Preliminary Bushfire Planning Advice

for the construction of the
Point Nepean Research and Education Field Station
at 3880 Point Nepean Road
Portsea VIC 3944

Prepared for the
University of Melbourne and Monash University

July 2021

Map 1 - Bushfire hazard site assessment and preliminary advice map.

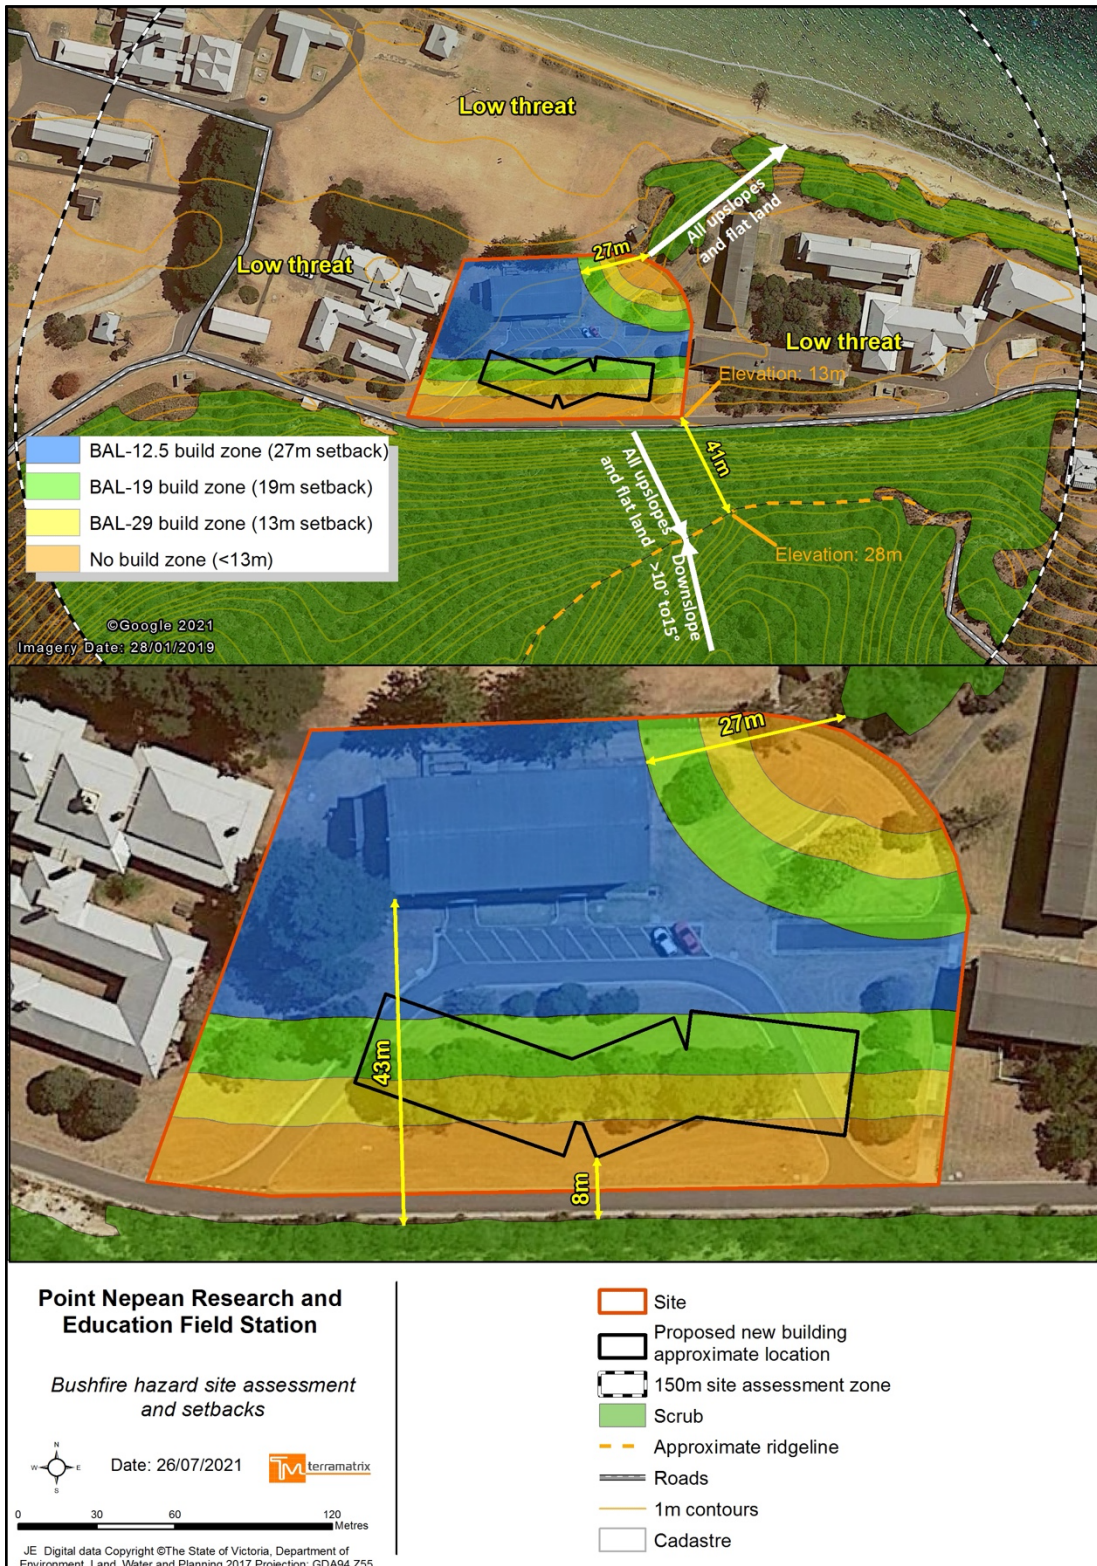
The proposed siting of the new building is problematic for BMO compliance. It is to be located approximately 8m from the Scrub on the dune to the south, which equates to a BAL-FZ construction standard. The maximum BAL permitted for group accommodation, or an educational facility is BAL-29, which requires a 13m setback from the Scrub.

The siting objective of the BMO also requires that development provides the maximum separation distance from the bushfire hazard, which would favour the new building being located between Badcoe Hall and the bay.

For the purposes of determining the BAL and defensible space, the applicable slope class is 'All upslopes and flat land' in relation to the Scrub to the south and north-east (see Map 1).

For the purposes of determining the BAL and defensible space, the applicable slope class is 'All upslopes and flat land' in relation to the Scrub to the north-east and south (see Map 1).
